**DEFENSE NUCLEAR FACILITIES
SAFETY BOARD**

Staff Report

August 11, 2025

Review of the Los Alamos Plutonium Facility Documented Safety Analysis

Figure 4: Representative HRR vs. time curve for one Plutonium Facility laboratory room.

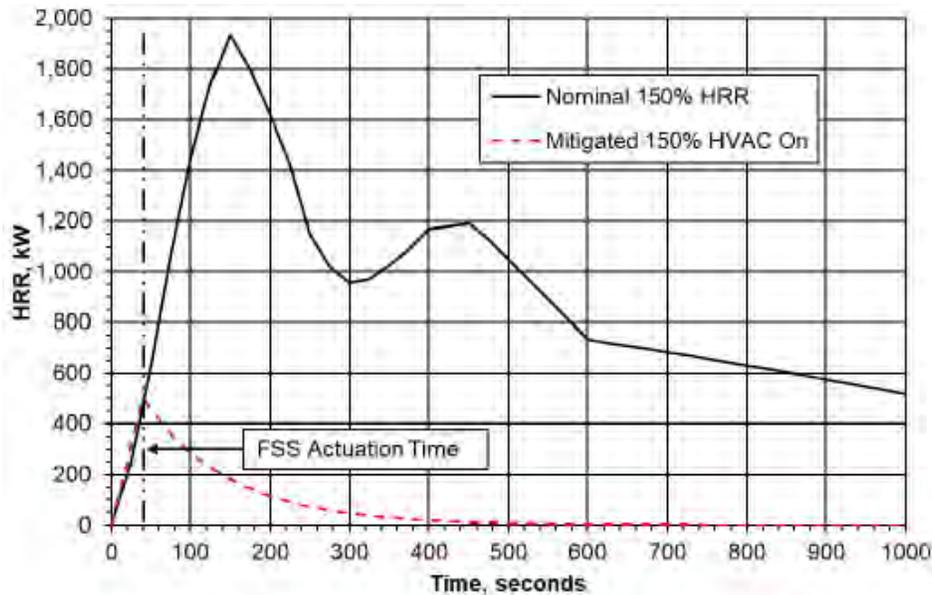
The solid black line represents the HRR associated with an unmitigated fire involving one cluster of combustible materials; the increases and decreases represent the ignition, burning, and extinguishing of individual items (each with different combustible characteristics), which add together to make the total curve. The red dashed line represents the HRR that LANL analysts calculated (using CFAST) following FSS actuation, based on the FSS characteristics (e.g., actuation temperature, water flowrate) input into the code.

The staff team noted during discussions that the significant downward slope of the red dashed line is not typical in safety analysis. Typically, an FSS like the one installed in the Plutonium Facility is assumed to perform a “control” function, for which the red dashed line would instead extend horizontally from the actuation point, rather than a “suppress” function, which is represented by the curve currently on the graph. This difference is illustrated in Figure 5 below.

LANL analysts stated that the Plutonium Facility FSS is designed in accordance with requirements in National Fire Protection Association (NFPA) 13, *Standard for the Installation of Sprinkler Systems*, for Ordinary Hazard Group 2 occupancies, consistent with “spaces with moderate to high quantity and combustibility of contents,” and is therefore able to deliver a minimum of 0.2 gallons of water per minute per square foot (0.2 gpm/ft²) [15]. Since the FSS is a credited safety class system, these design characteristics are protected in the TSRs. They further argued that the Plutonium Facility has a much lower level of combustible loading than typical Ordinary Hazard Group 2 occupancies (which could involve large amounts of wooden furniture, bookshelves, carpet, and other items that the Plutonium Facility does not generally contain). Since this FSS is designed to “control” a fire in a facility with significantly higher combustible loading, they stated that they were confident in the ability of the FSS to lower the HRR consistent with their analysis (i.e., the red dashed line in Figure 4).

However, the staff team noted that the trajectory of the HRR after FSS actuation—which follows from the 0.2 gpm/ft² flowrate assumption—relies on near-perfect energy transfer from fire to water, without any safety margin to account for unfavorable conditions or other inefficiencies. Water can pool or behave in other ways that do not directly contribute to removing energy from fires. Not accounting for these effects may result in an overstating of the true FSS efficacy. LANL did perform some scoping analysis of HRR as a function of lower FSS water delivery to reflect potential system degradation (e.g., only 50% of the water is delivered through sprinklers). LANL’s analysis of a generic room fire, taken from the combustible loading calculation updated after the staff team’s site visit, is shown in Figure 6 [16]. While this analysis was performed for a different purpose (and, as stated above, FSS characteristics are protected in the TSRs), carrying this analysis forward to determine LPF for those scenarios may be an appropriate method for adding appropriate safety margin.

Figure 5: Generic representation of the difference between control and suppression of fires.

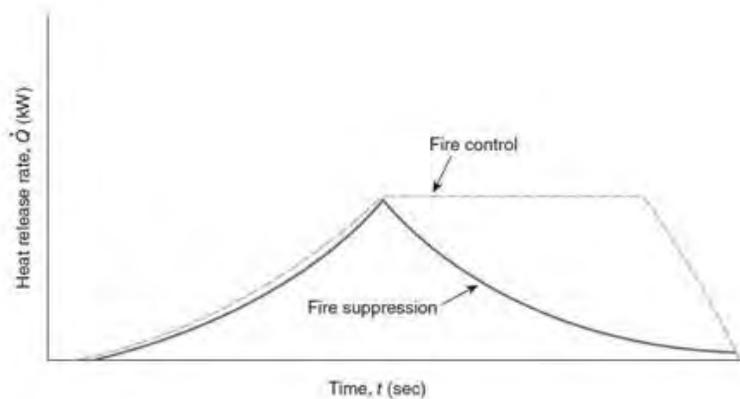
Without explicit design (such as deluge systems or inert gas systems), it may be inappropriate to assume the FSS behavior assumed in Figure 4, since it could overstate the efficacy of heat removal and therefore overstate the effects on calculated LPF and dose consequences.

Figure 6: LANL’s analysis of different throughputs of fire water—reflecting degraded FSS conditions—and the subsequent effects on HRR. This analysis could be extended as a method for adding safety margin to key LPF calculations.

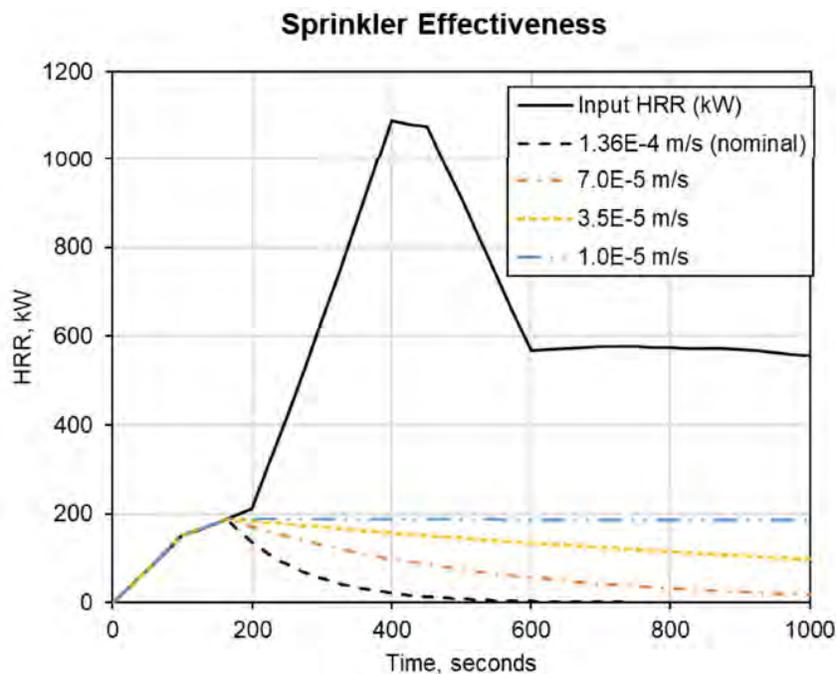
Additionally, the staff team noted that LANL’s combustible analysis does not adequately account for the possibility of fires occurring in locations where the FSS spray pattern may be impeded. This could also affect the assumed FSS actuation time and therefore also affect calculated dose consequences (e.g., fires could start underneath obstructions and burn for a time without heat flux directly being “seen” by sprinklers). During discussions, LANL analysts stated that, given the sprinkler coverage in the Plutonium Facility and expected spray patterns and angles, there would be few areas completely hidden from coverage. However, these conclusions are in part based on the facility configuration observed during walkdowns, rather than a generalized and conservative analysis of potential facility configurations. In a conservative safety analysis using a novel approach to crediting fire suppression, the staff team believes this possibility should be more comprehensively considered and accounted for.

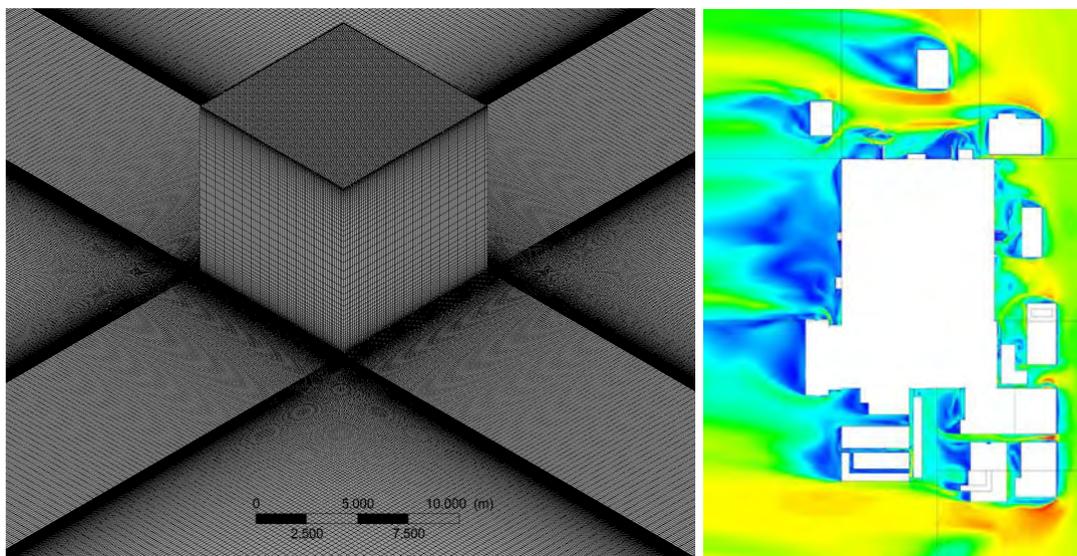
Further, there are still documented issues with validation for references used in this submitted version of the safety basis. The CFD methodology document for the Plutonium Facility states the following:

A model validation was conducted based on a standardized case of flow passing perpendicular to a cube. Experimental pressure coefficient contours on cube surfaces provided by literature and American Society of Heating, Refrigeration, and Air-Conditioning Engineers (ASHRAE) standards were compared to the modeling approach applied to the non-seismic and seismic analyses conducted. Unity was not achieved between the numerical predictions and experimental results; however, the model currently implemented was able to match the front face perfectly and match the expected behavior on both sides, the top, and the back with error less than approximately 10% for regions with large pressure gradients and where those gradients were expected on the cube surfaces geographically [18].

In other words, LANL created a simple geometric model to validate use of this CFD software, and that simple model did not fully align with experimental results as expected. Since good agreement could not be achieved with the simple cube model (pictured in Figure 7), the LPF values that are obtained using more complicated models also have questionable precision (an example of which is also pictured in Figure 7).

Additionally, the use of several interconnected models and computer codes to calculate LPF creates opportunities for compounding uncertainties. For example, the Fluent model of the

Plutonium Facility includes uncertainties in the grid size used (as shown in the grid refinement study) and in the modeling approach when compared against a standard cube model (as discussed above); feeding models with those uncertainties into further models in sequence creates the opportunity to compound existing errors, since mismatches between the boundary conditions of steady-state and transient models create additional opportunities for uncertainty propagation during handoff. An error propagation analysis—which is commonly done when several computer models are used in sequence—was not performed. LANL analysts agreed that there are opportunities for improvement in model handoffs.

Figure 10: Simplified diagram of the fire loop in TA-55. Following seismic events, non-nuclear buildings with lower seismic pedigrees must be separated from the loop to ensure water is delivered to nuclear facilities.

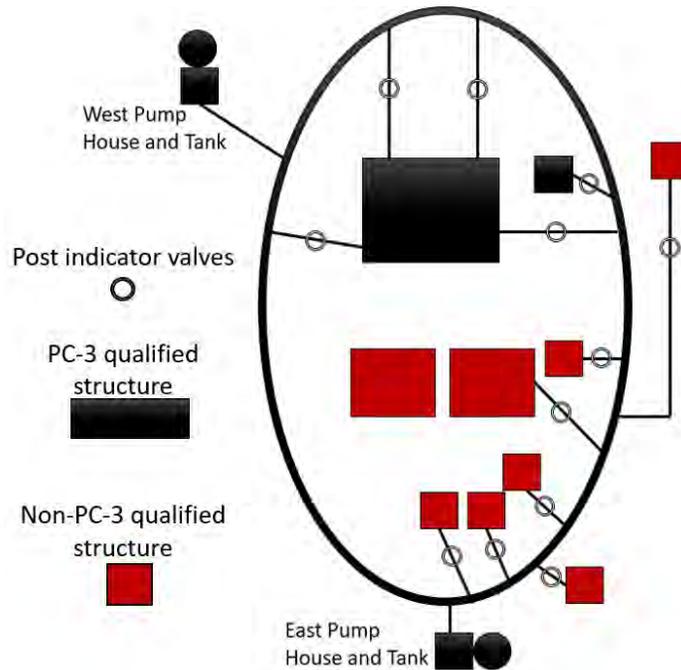
Fire Water Supply Loop Upgrades—As mentioned above, one ongoing project in TA-55 involves the supply of fire suppression water to the Plutonium Facility and other buildings. Many structures in TA-55, including nuclear and non-nuclear facilities, are connected to the same water supply. This creates a seismic vulnerability (demonstrated in Figure 10), since a break in the supply lines to non-nuclear facilities—which are not seismically qualified—could prevent water from being delivered to the Plutonium Facility. Personnel are working to install an alternate supply to non-nuclear buildings. Work on this project, which is tracked under facility operating funds, was expected to be completed in 2026; however, facility personnel stated that there were complications associated with the planned routing of the feed lines to the Plutonium Facility, which may cause delays. In the interim, preparatory work to facilitate separation of non-nuclear buildings from the common feed can still proceed. The final separation will not occur until after the new feed line is completed.

Currently, the Plutonium Facility DSA has administrative compensatory measures in place to account for this known vulnerability. Following seismic events, facility personnel are required to manually turn off the water supply to non-nuclear structures by closing a series of post-indicator valves located outside, in the TA-55 yard. While this action may ensure that the Plutonium Facility receives the required flow of fire suppression water, it is only appropriate as a

short-term solution as it (1) requires administrative actions by personnel in a post seismic environment which are less reliable than engineered systems, and (2) hampers the ability to fight fires in important non-nuclear buildings.
